FIELD ORDER SUMMARY

Project: Saranac Lake Gas Co. Remedial Action	Project Location: Village of Saranac Lake, Essex County, New York
Client: NYSDEC	NYSDEC Site No.: 516008
Contractor: LAND Remediation, Inc.	MACTEC Project No.: 3611181219

FIELD ORDER

Project Name:	Saranac Lake Gas Company, Remedial Action	FO No.: 1
Project Location:	Village of Saranac Lake, Essex County, New York	Date Issued: 7/17/2018
		Site No.: 516008
Client:	New York State Department of Environmental Conservation (Department)	Contract No.: D010663
Contractor:	LAND Remediation, Inc.	Associated RFI or PCO: <input type="checkbox"/> RFI No. ___ <input checked="" type="checkbox"/> PCO No. 4 <input type="checkbox"/> None
MACTEC Project No.:	3611181219

If yes, describe: Figure 1 – Confirmation Sediment Sampling Plan

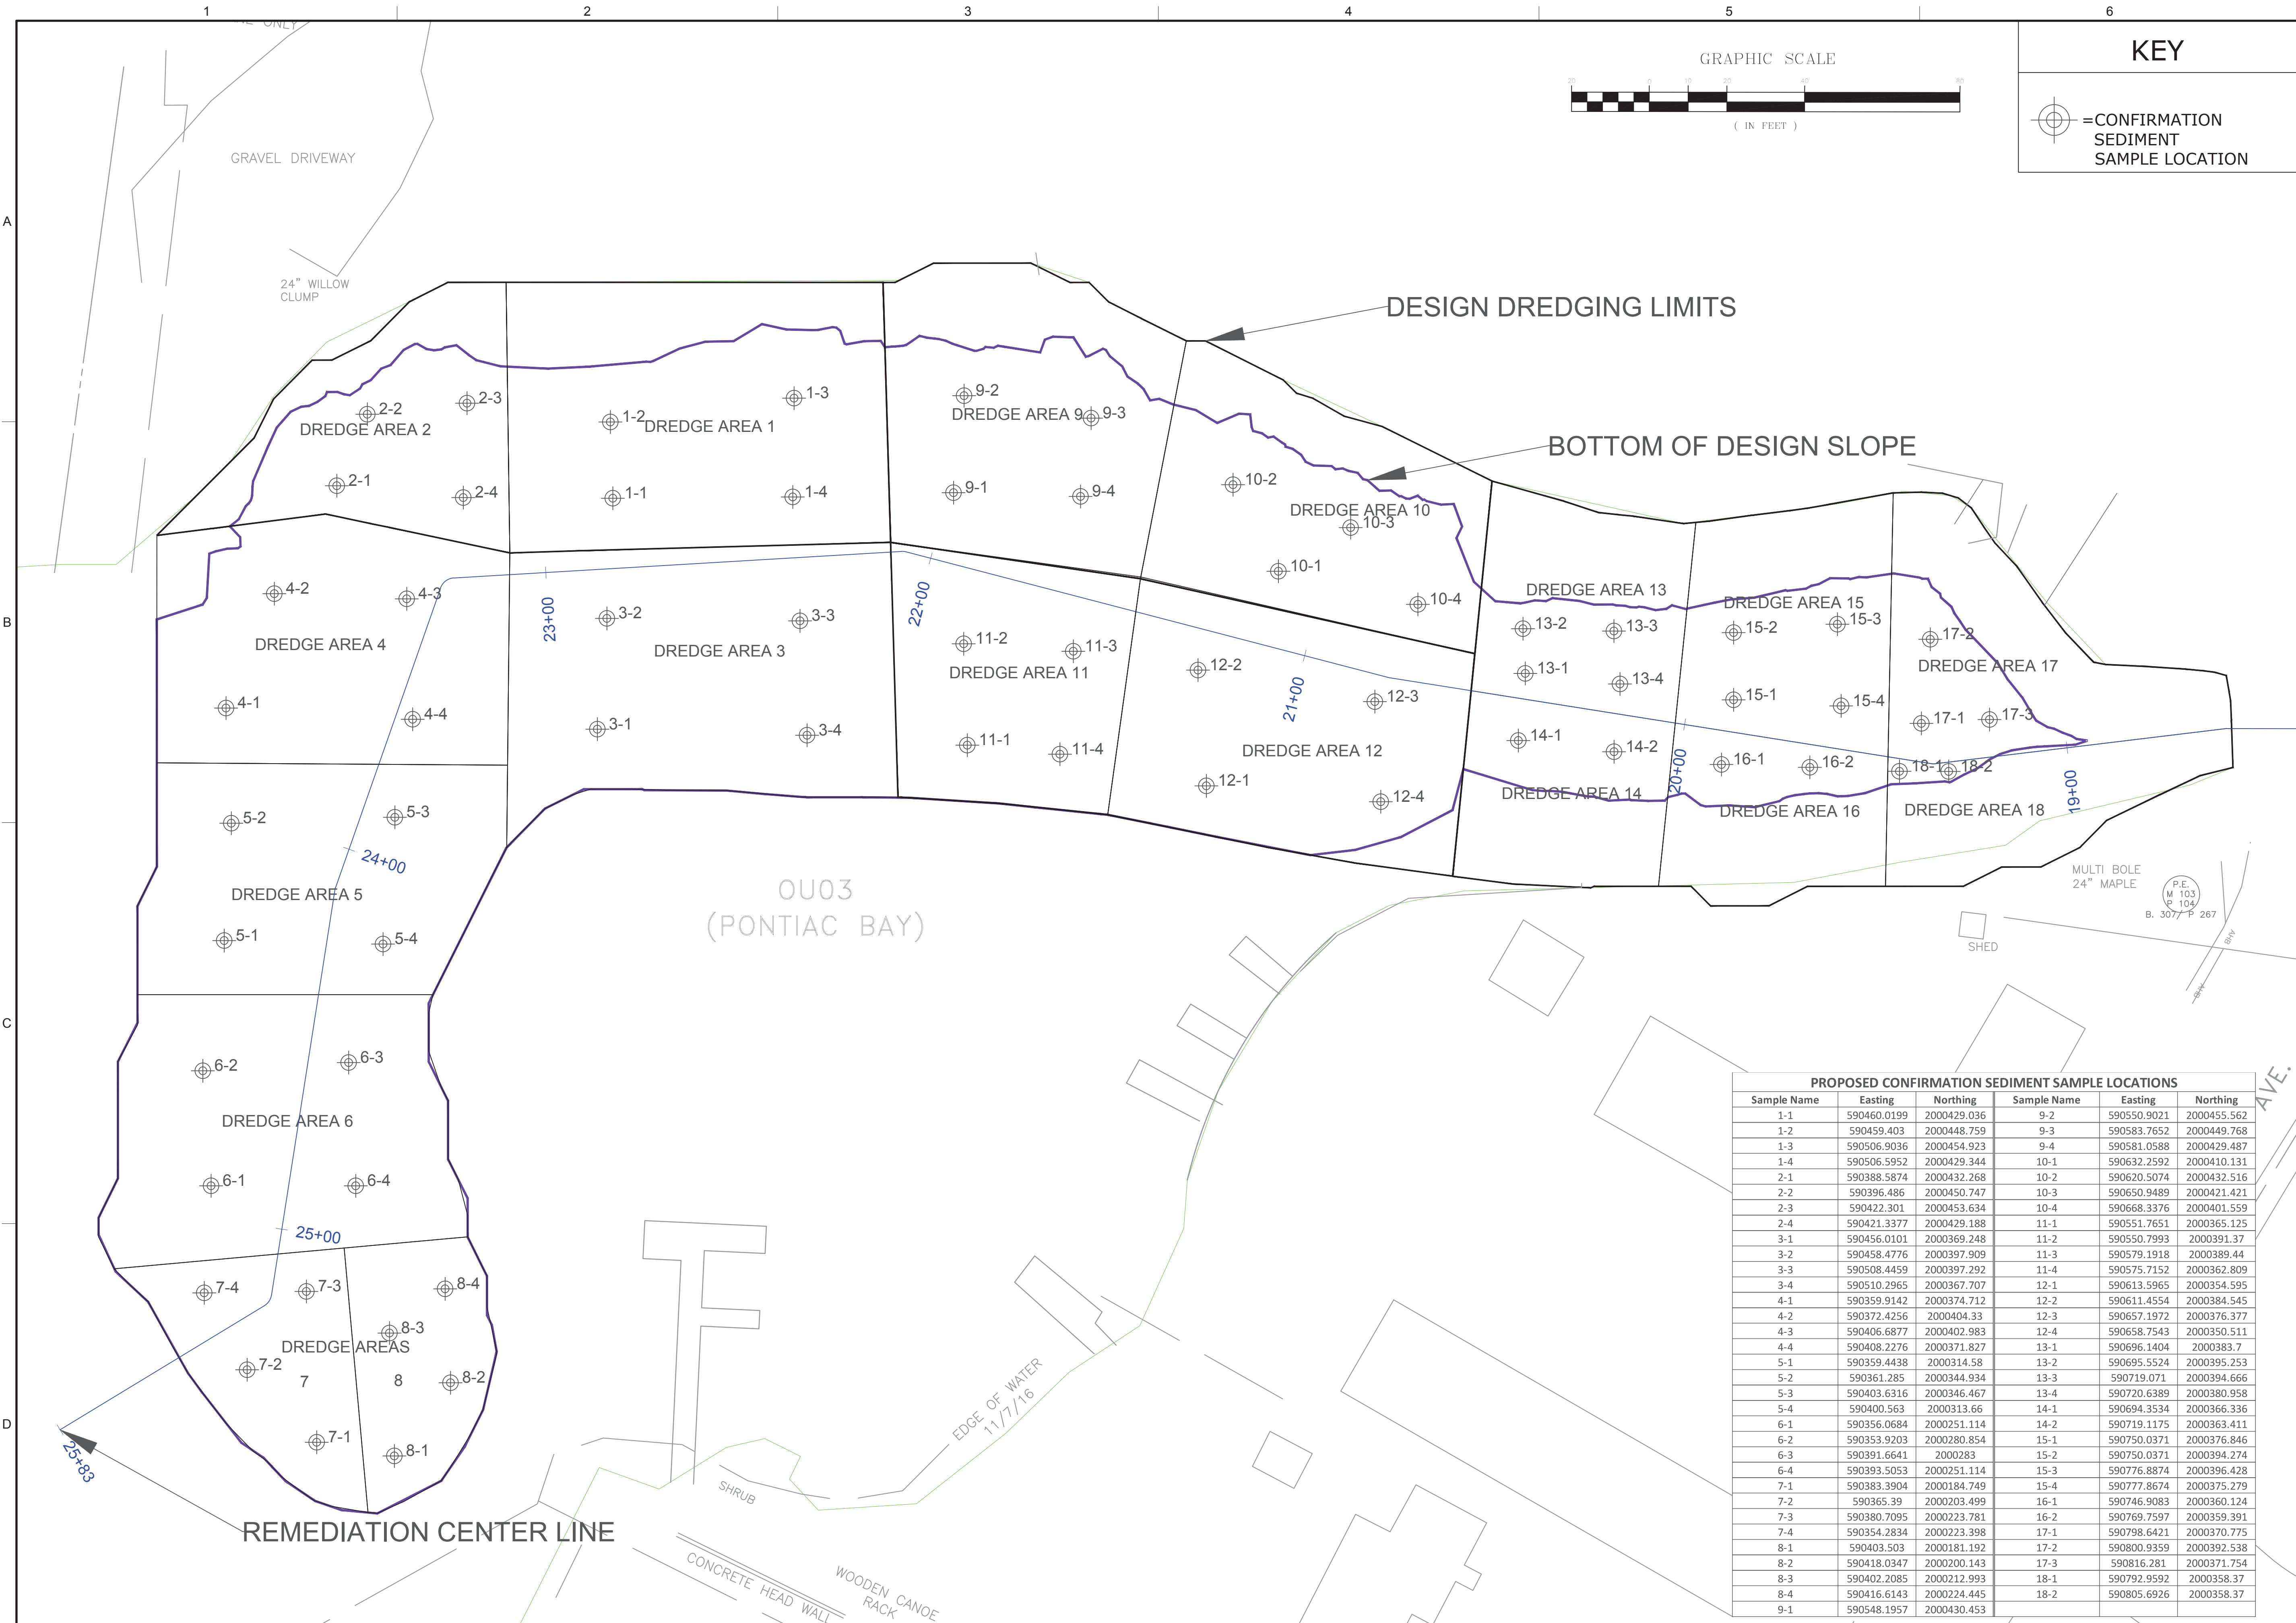
Post-confirmation samples shall be collected as specified in Section 01 45 28 of the contract specifications and consist of the collection of discrete samples from each of the 18 dredge areas as shown on Figure 1. Sediment from each discrete sample within each area of the 18 dredge areas shall be used to make a composite sample representing the respective dredge areas. The 18 composite samples and 65 discrete samples shall be sent to the approved laboratory. The laboratory shall analyze the 18 composite samples per Section 01 45 28 of the contract specifications and archive the 65 discrete samples pending review of the composite sample results. Composite sample analytical results will be compared to the applicable Sediment Cleanup Objectives for the Class A Sediment Criteria for the identified primary contaminants of concern (COC) for the Site. If cleanup objectives are not met based on the results of the composite sample for each of the 18 areas, the representative discrete samples for that area(s) shall be analyzed for the COC(s) that exceeded the acceptable limits.

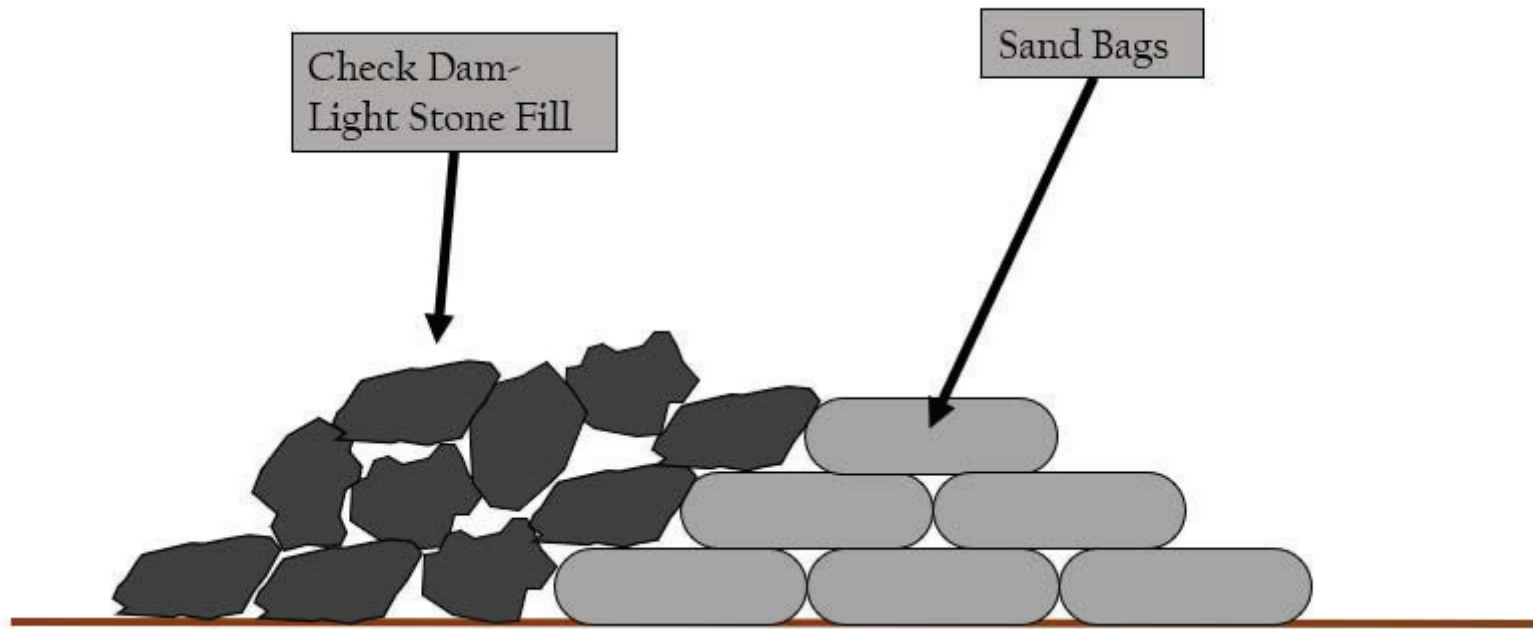
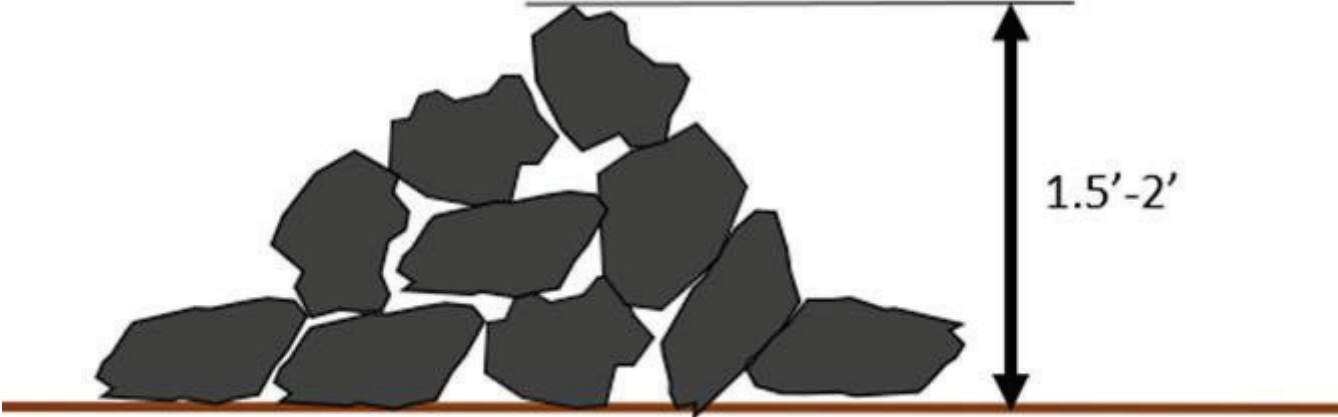
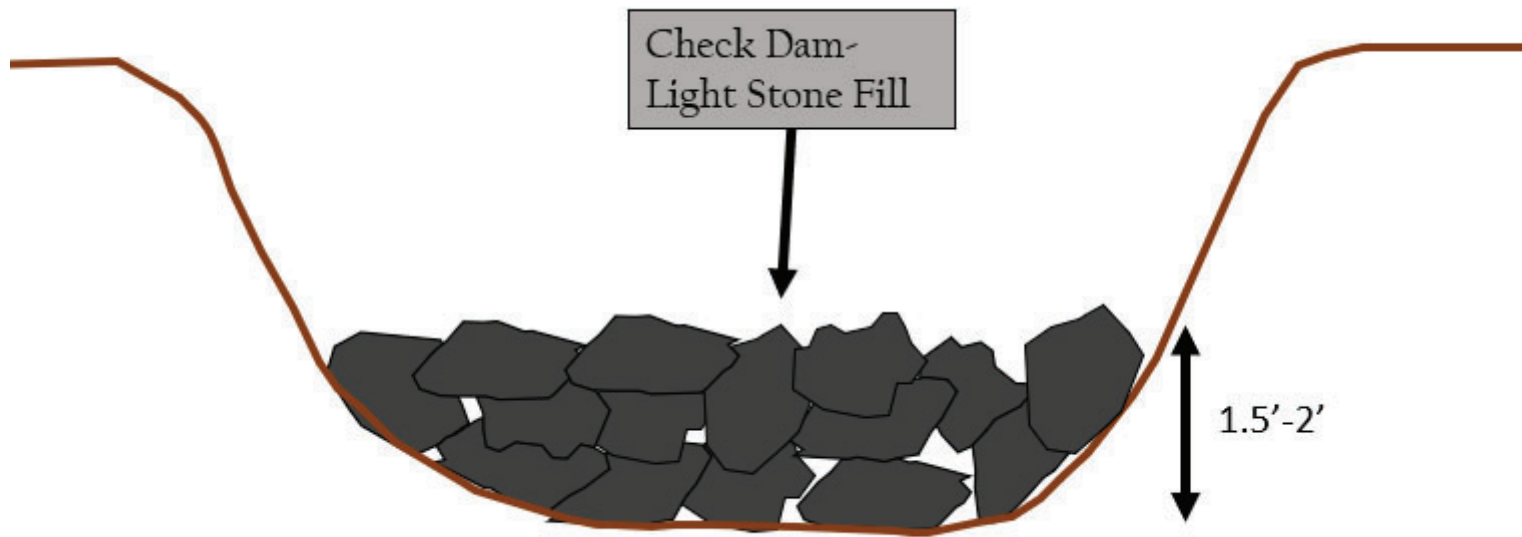
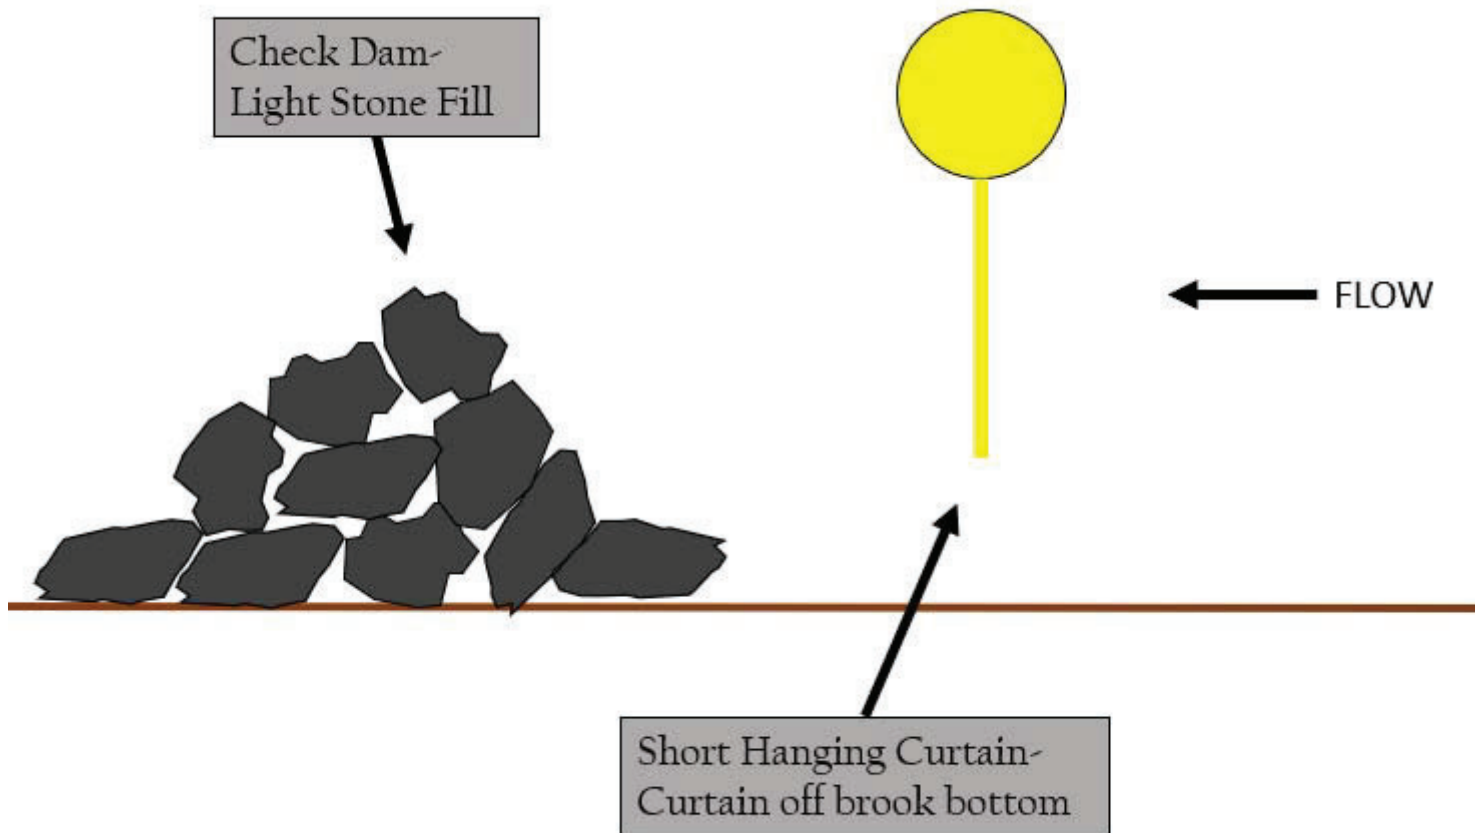
Below are my concepts for the Brandy Brook Sediment controls. Locations are conceptual and will be determined in the field. The Bypass will discharge just upstream of the Railroad Culvert.

Sand Bag/ Check Dam- FYI- I still have doubts that the sand bags will remain in the event of a large storm surge

Check Dam-
Light Stone Fill

CHECK DAM/ SHORT SILT CURTAIN

I have no issues with the proposed approach. There may have to be some field adjustment if there are issues with the sand bags or check dams staying place during storm surges. Field observations should be conducted to verify control measures are successful in capturing sediments.
